Product Change Notification / LIAL-08GDCX402

CCB 3156.002 Final Notice: Qualification of MMT as a new assembly site for selected AT17LVxxx and AT24Cxxx Atmel device families available in 8L PDIP (.300in) package.

**CCB 3156.002**  
**Pre and Post Change Summary**  
**PCN#: LIAL-08GDCX402**

# Lead frame comparison

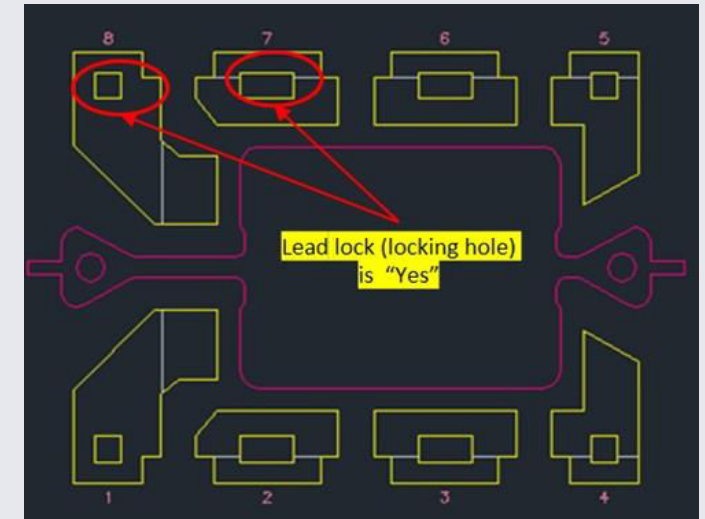
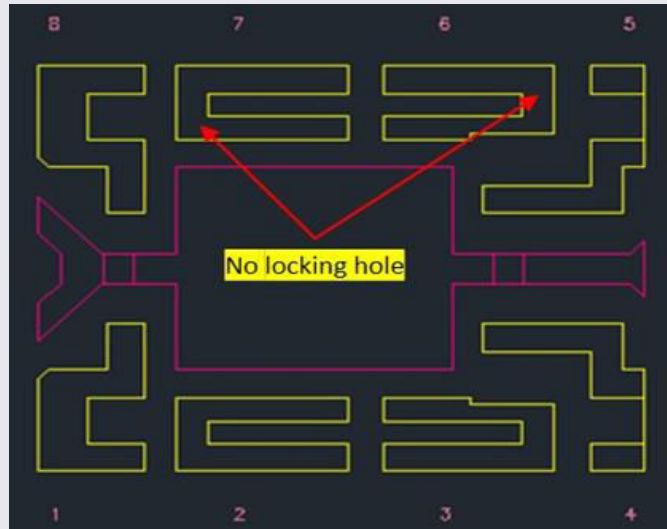
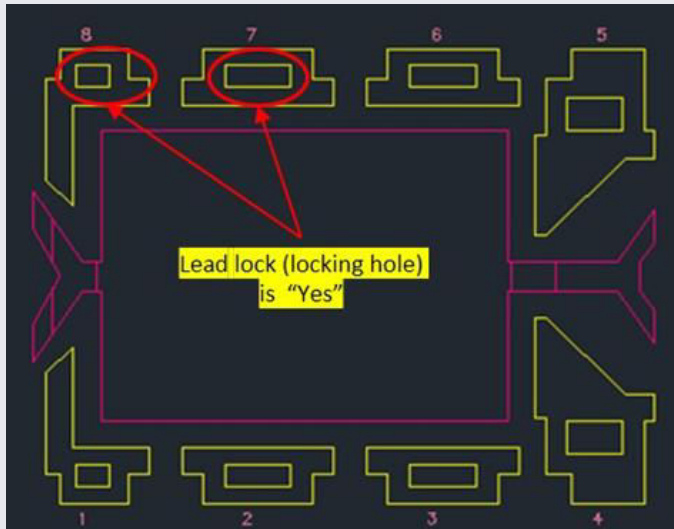
Lead frame lead-lock	Yes
Lead plating	Matte Tin
Paddle size	160x120mils

Lead frame lead-lock	No
Lead plating	Matte Tin
Paddle size	110x134mils

Lead frame lead-lock	Yes
Lead plating	Matte Tin
Paddle size	140x180mils

**NOTE:** Mold compound material fills the [lead lock hole](#), which provides improved protection against moisture penetration along the edge of the leads (pins) of the package.
